Development Application: 444-450 Gardeners Road, Alexandria

File No.: D/2017/240

Summary

Figure 18: Amended ground floor plan

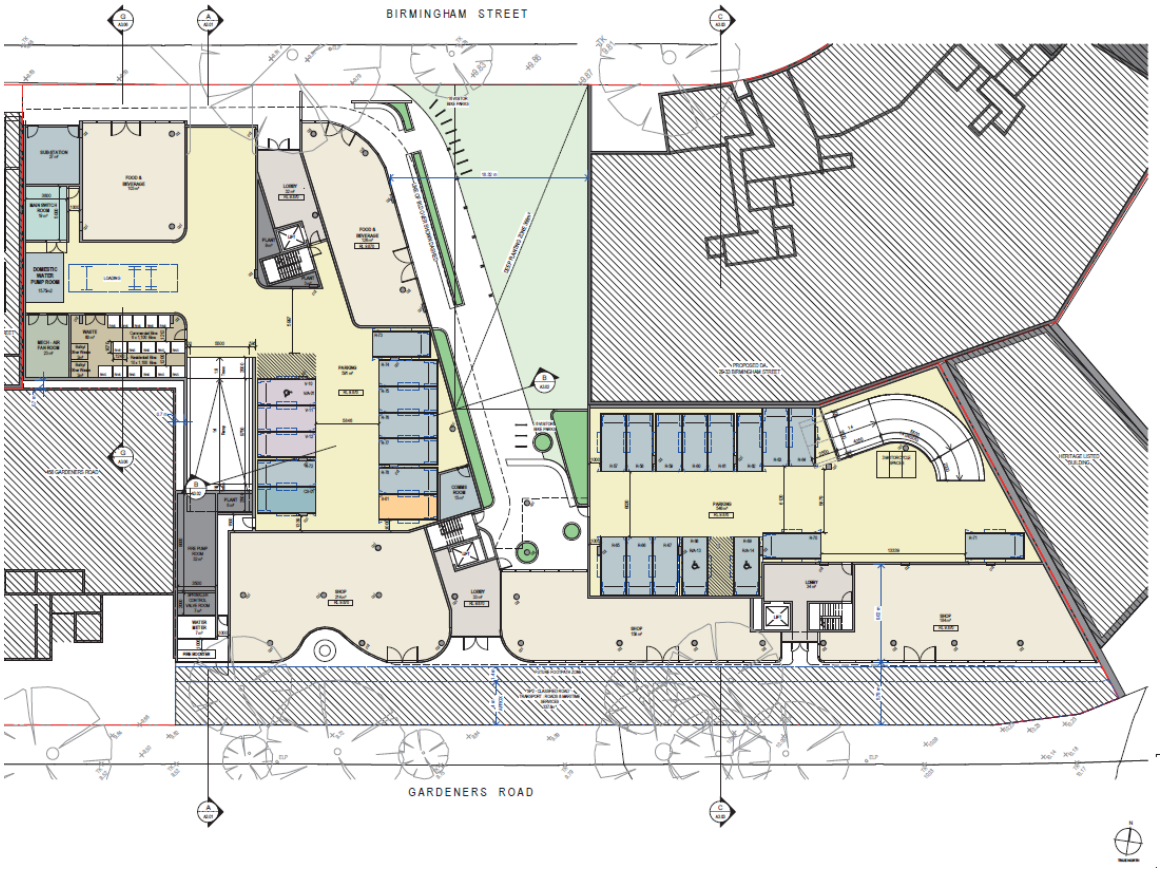
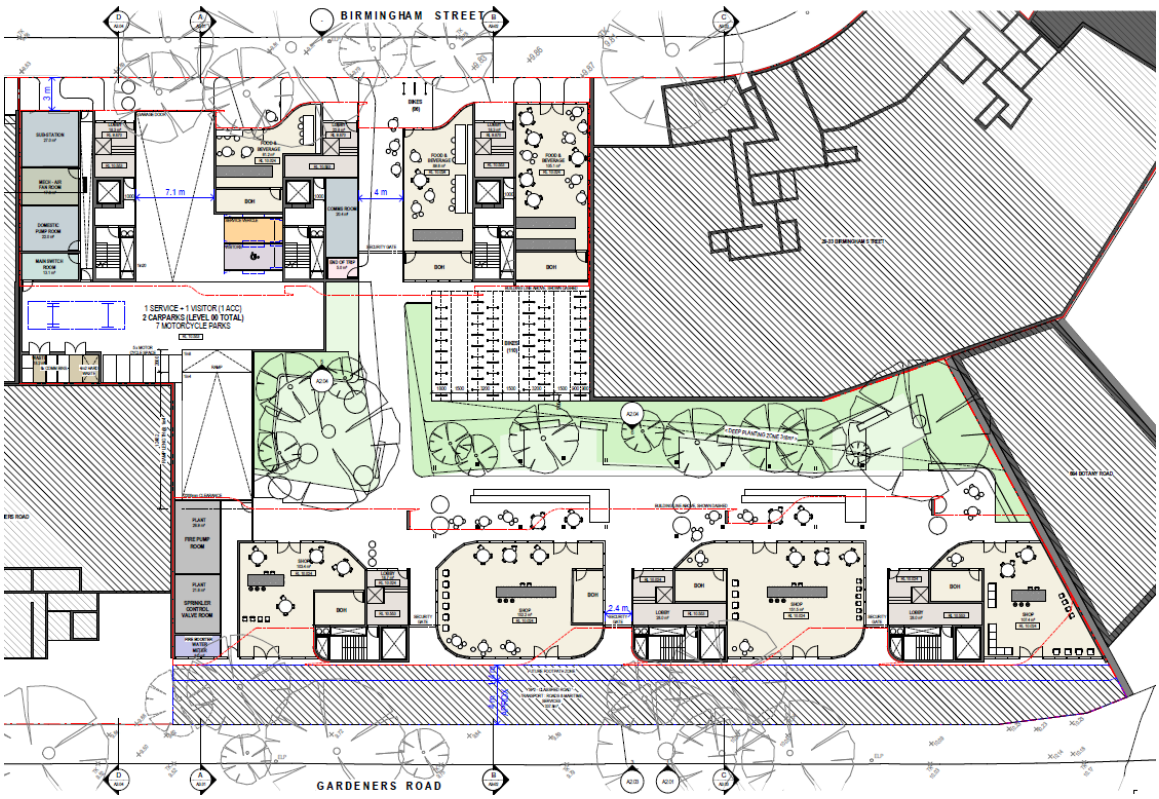
55. At the time of lodgement of the original development application in March 2017, the scheme was for one continuous built form that connected the Gardeners Road side of the site with the Birmingham Street side of the site.

60. Amended plans that formally amended the proposal were submitted on 15 November 2017 and 23 January 2018 to result in the current built form providing two separate buildings adjacent to both street frontages, with a ground floor courtyard within the centre of the site. Selected plans outlining the amended built form is illustrated at Figures 18 and 19, below.

(b) Reconfiguration of the built form to provide a continuous built form along both the Gardeners Road and Birmingham Street frontages.

(d) Removal of all single sided apartments fronting onto Gardeners Road, and orientating apartment layouts so that living areas front onto the northern high amenity side.

(e) Further resolution of solar chimney design to apartments fronting Gardeners Road. Further discussion on the solar chimneys is outlined below.

Figure 20: The Gardeners Road elevation showing the 22m height limit.

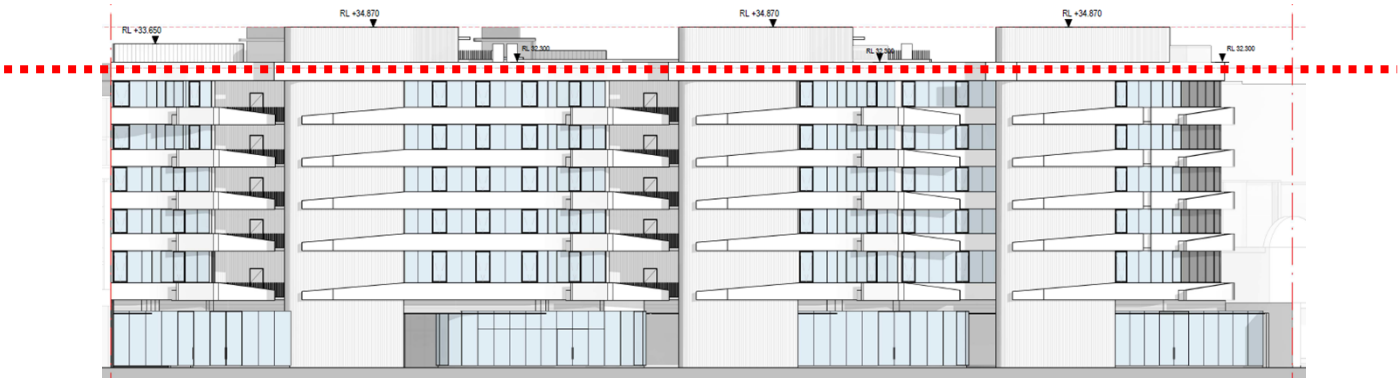
67. Figures 20 and 21, below, illustrate the 22m height control on the elevations of both street frontages and shows those elements of the scheme above the building height development standard.

75. The non-compliance is related to the communal roof terrace, including pergola structures and lift and stair access. The proposed development is considered to represent a better planning outcome for this site and to be in the public interest. This is because the development provides good amenity, represents an acceptable heritage outcome, does not adversely impact on the amenity of surrounding residents and presents a good design outcome.

Figure 22: Typical apartment layouts adjacent to Gardeners Road, with solar chimney location.

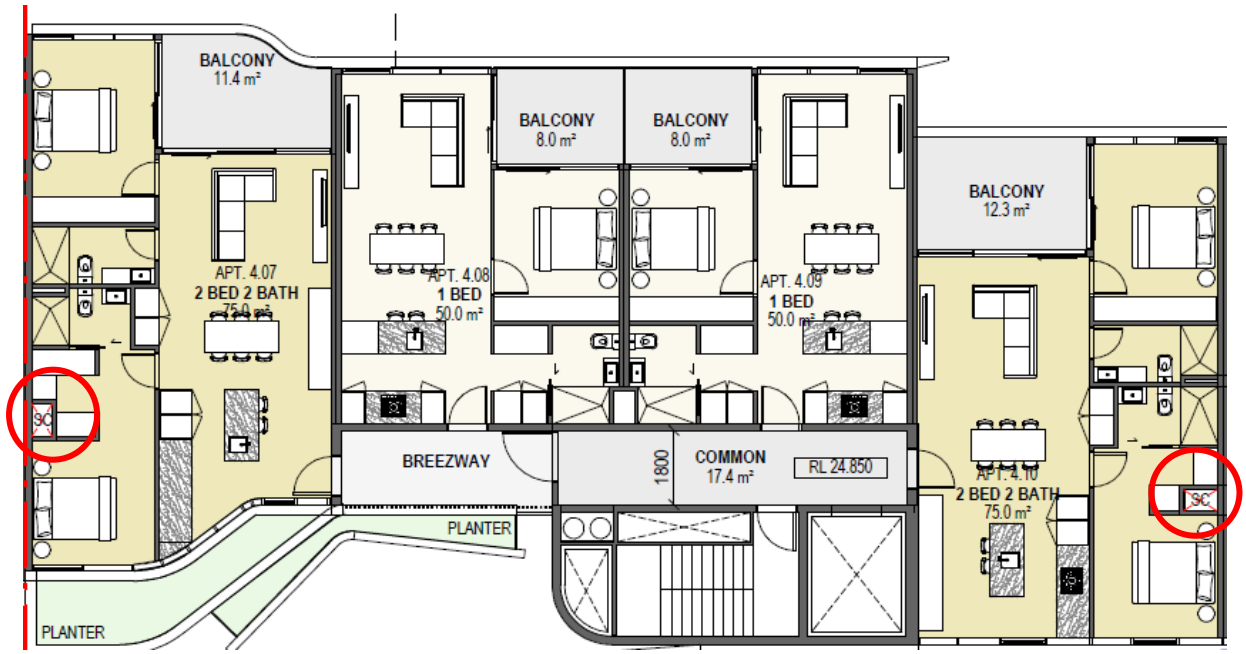
77. The application has proposed solar chimneys to the apartments fronting onto Gardeners Road. The apartment design locates one bedroom from each two-bedroom apartment adjacent to Gardeners Road, with all other bedrooms and living rooms fronting onto the northern side of the building. The solar chimneys allow these bedrooms to achieve natural ventilation whilst also achieving acoustic amenity when the windows to Gardeners Road are closed. The typical apartment layouts adjacent to Gardeners Road, including the location of Solar Chimneys (SC) are shown in Figure 22 below.

78. The solar chimney design has been accompanied by an Engineers Report. The City has had these plans and the accompanying information peer reviewed by a sustainable building consultant, FLUX Consultants. The peer review has identified that, while the design is supportable in principle, further work is required to adequately

79. It is therefore recommended that the solar chimney design be subject to a number of deferred commencement conditions to ensure that there is further design resolution of the chimneys. The space allocated within the floor plans is an acceptable size and will ensure that further design resolution will not result in any amendments to the apartment floor plans or an increase in the height of the chimneys.

(e) Screening of solar chimneys.

Figure 24: The draft plan of subdivision showing the dedications adjacent to the Gardeners Road boundary.

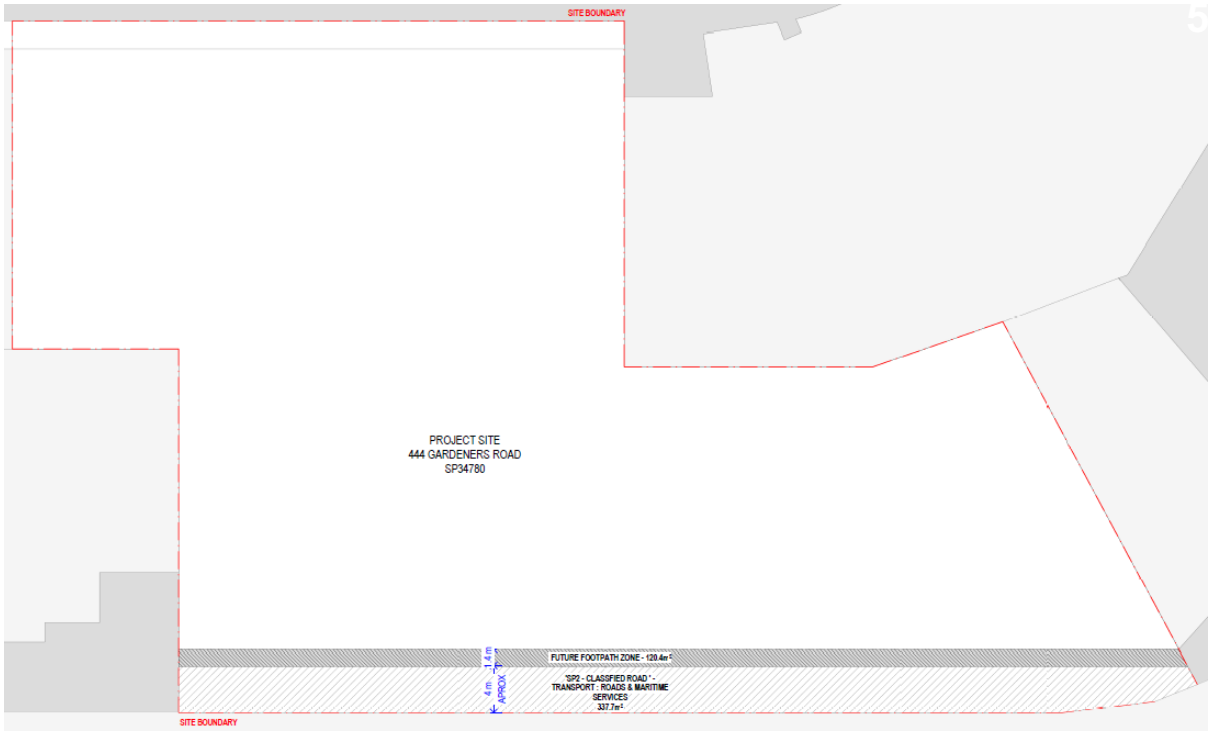
85. A Voluntary Planning Agreement (VPA) has been prepared in relation to the site. The agreement included the following public benefits:

(b) The embellishment and dedication of an additional 120.4sqm of land to provide a 1.4 metres front setback of the site adjacent Gardeners Road, as required by the Sydney DCP 2012.
